TRANS/WP.29/GRE/2003/35
7 July 2003

PROPOSAL FOR DRAFT AMENDMENTS TO REGULATION No. 112

(Headlamps emitting an asymmetrical passing beam)

Transmitted by the expert from the Working Party "Brussels 1952" (GTB)

"Figure D
Primary Driving Beam

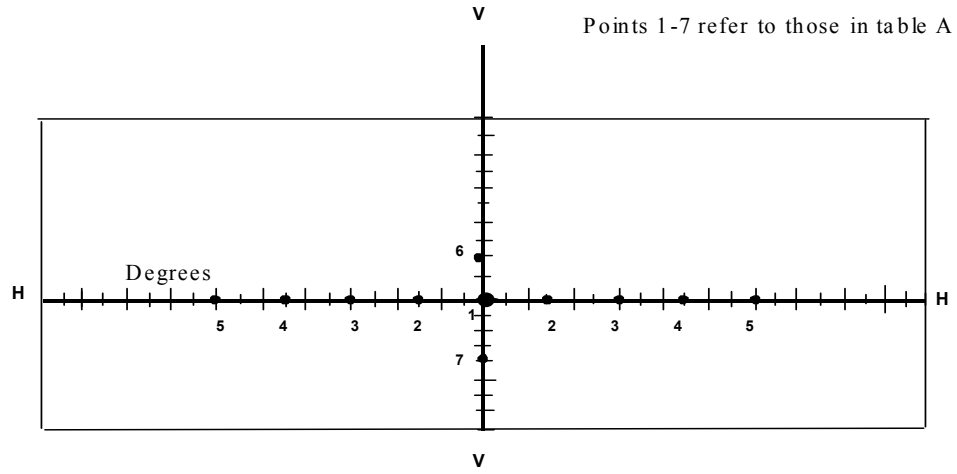
Add at the end of annex 3 figures D and E, to read:

Refer to Figure D for details of test point positions

TEST POINT NUMBER	TEST POINT LOCATION	Required illumination in lux	
		Min.	Max.
1	H-V (1/)	(1/)	---
2	H-3R & 3L	20	---
3	H-6R & 6L	7	---
4	H-9R & 9L	4	---
5	H-12R & 12L	1.2	---
6	2U-V	2	---
7	4D-V	---	(2/)
	MAX. LUMINOUS INTENSITY	50	180.0

- (1/) Intensity at H-V shall be equal to or greater than 80 per cent of the maximum intensity in the beam pattern.
- (2/) Intensity at 4D-V shall be equal to or less than 30 per cent of the maximum intensity in the beam pattern.
